**REQUEST FOR TENDERS
LIBRARY REFURBISHMENT
RFQ 34 (2022-06)
ADDENDUM #2**

LIBRARY
RE-CONFIGURATION

A3.01

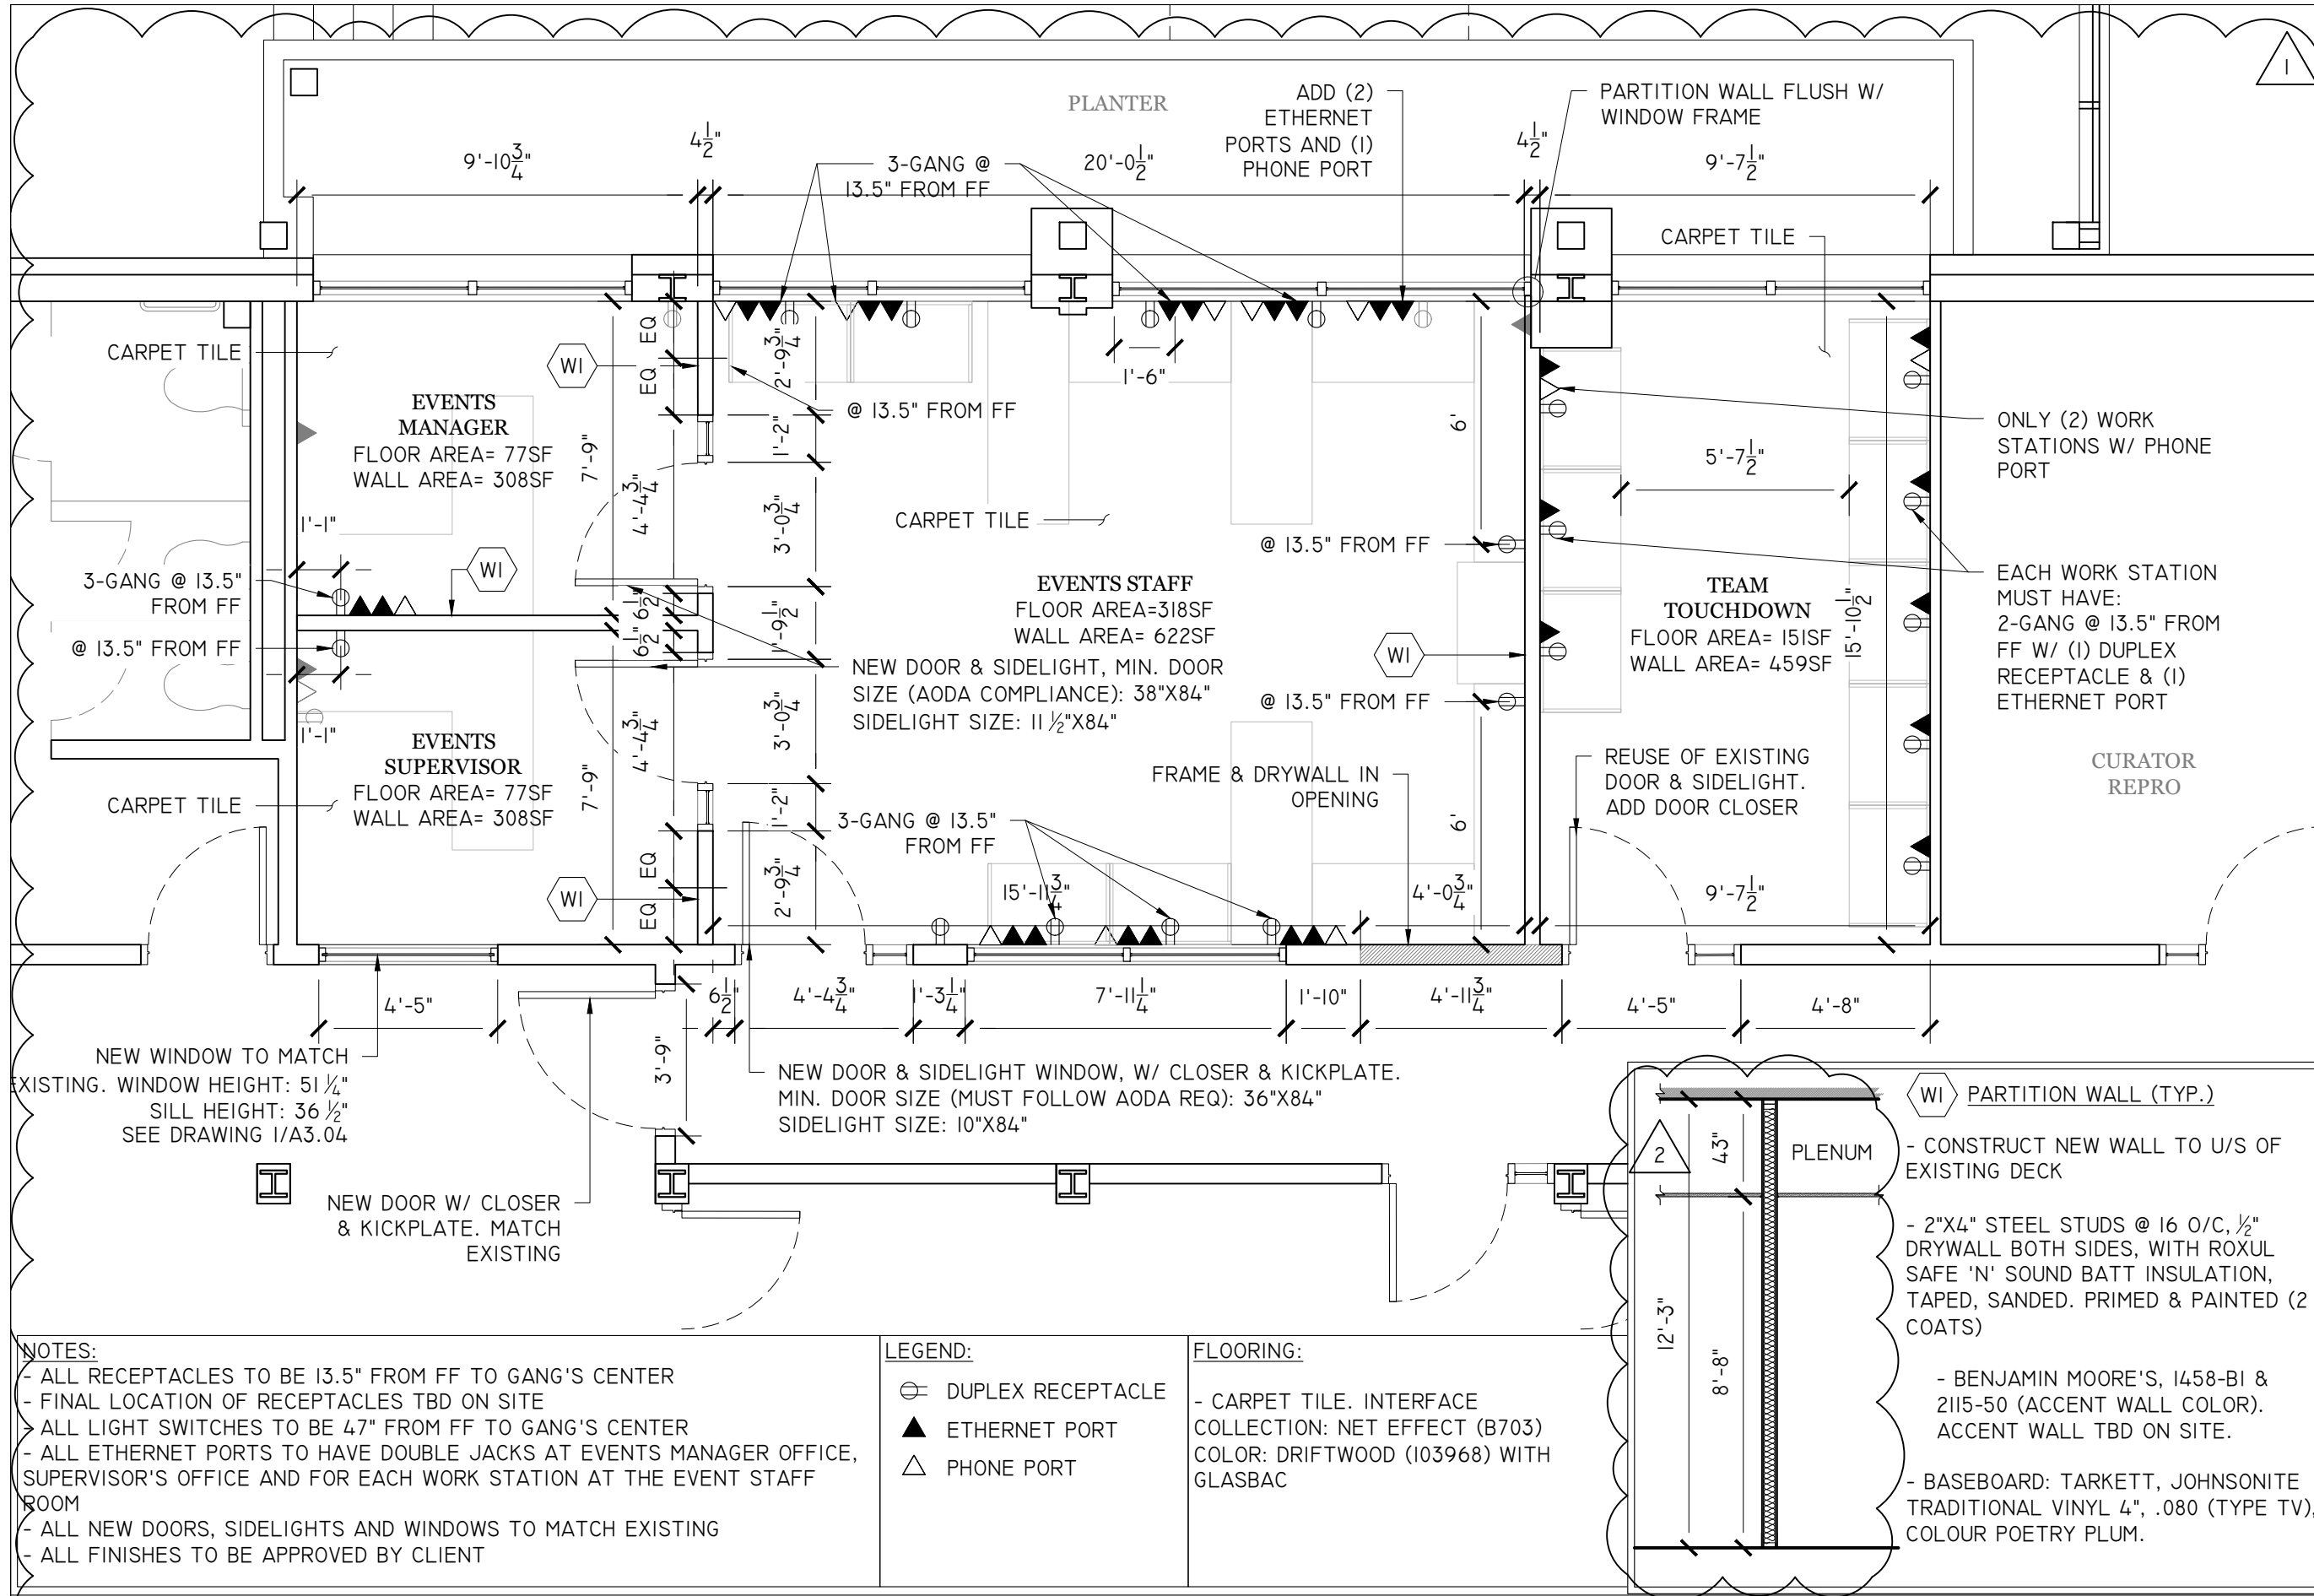
5. **QUESTION:** What is the existing deck height, if the steel studs for the walls have to go to the underside of deck?

6. **QUESTION:** What kind of flooring base will be used? Carpet or vinyl?

7. **DELETE DRAWINGS:**

A3.01 R1 – Proposed Layout

RESPONSE: Please refer to the revised plan A3.01. There is 43" from U/S of ceiling to U/S of deck.

RESPONSE: Please refer to plan A3.01.

A3.01 R2 – Proposed Layout
